Re: Historic Landfill H0167-01 Barnageeragh Cove. Draft Certificate of Authorisation.

In accordance with Regulation 7(5) of the Waste Management (Certification of Historic Unlicensed Waste Disposal and Recovery Activity) Regulations 2008, Fingal County Council (FCC) makes the following representations to the Agency on the draft certificate of authorisation (CoA), register number H0167-01.

Figure 1 Consented MUGA Layout within Area 2.

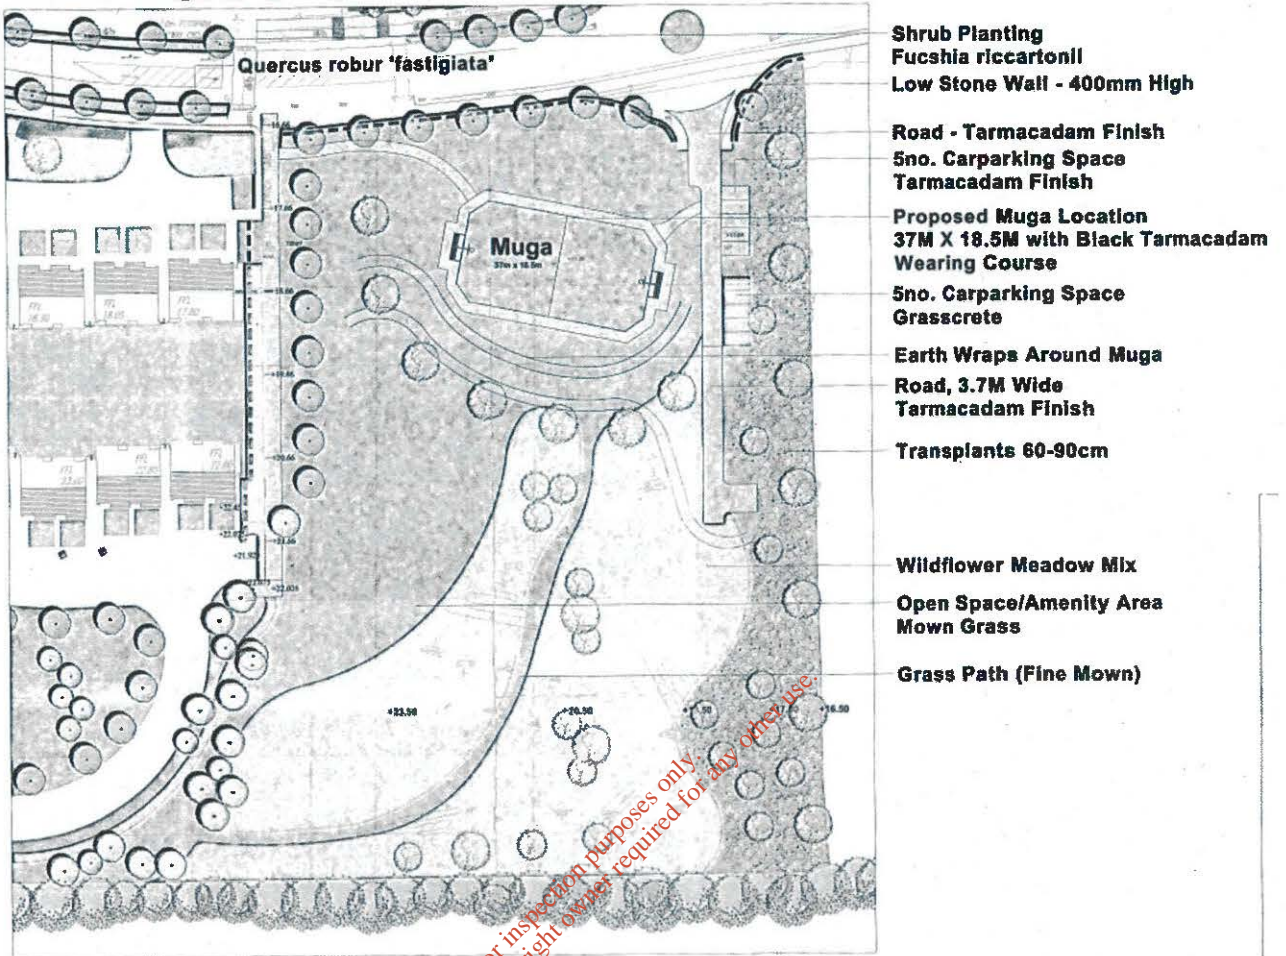
FCC would note that Area 2 has planning permission for the construction of a multi-use games area (MUGA) and associated works and landscaping (refer to **Figure 1**). The installation of a system of 6m high gas vent stacks across Area 2 would likely preclude the development of the MUGA.

Therefore, FCC requests that the Agency consider only conditioning the installation of the passive gas venting system in the area along the boundary between Area 1 and Area 2 with 12 months of monitoring to be undertaken. Subject to Condition 3(c) (iii) – discussed further below – a gas cut-off trench or similar may be installed in Area 2 following 12 months of monitoring.

The installation of an engineered landfill cap over Area 2 will serve no significant purpose. The impermeable capping layers are designed to prevent rainwater infiltrating through to the waste body and potentially generating leachate. As noted in the Tier 2 and Tier 3 Environment Risk Assessment, no waste of any significance was encountered in the trial pits in Area 2. The "waste" in Area 2 can largely be characterised as soil and stones. Taking a worse-case scenario into consideration for Area 2, it could be deemed to be an inert landfill. In accordance with Figure 10.1 (p.97) of the EPA Landfill Site Design Manual, the minimum thickness of capping required is 0.5m of soil (topsoil and subsoil). Where tree planting is required, this is increased to 1m in total as per Table 4.3 (p.23) *Recommended Minimum Soil Depth (After Placement) Required For Restoration For Various Landfill Types* of the EPA Landfill Manual Landfill Restoration and Aftercare. The combination of the landscaping already in place and the proposals for the MUGA will effectively meet this inert landfill requirement for capping.

As noted in this letter and as shown in **Figure 1**, there are plans to fully landscape Area 2 and construct the MUGA. Condition 3.6 will delay completion of the MUGA works for at least 12 months if not longer.

Taking all of the above into consideration, FCC considers that the potential requirement to install an engineered landfill cap in Area 2 is unnecessary and unsustainable given the extremely low risks involved and therefore FCC requests that the Agency consider deleting this condition from the final CoA.
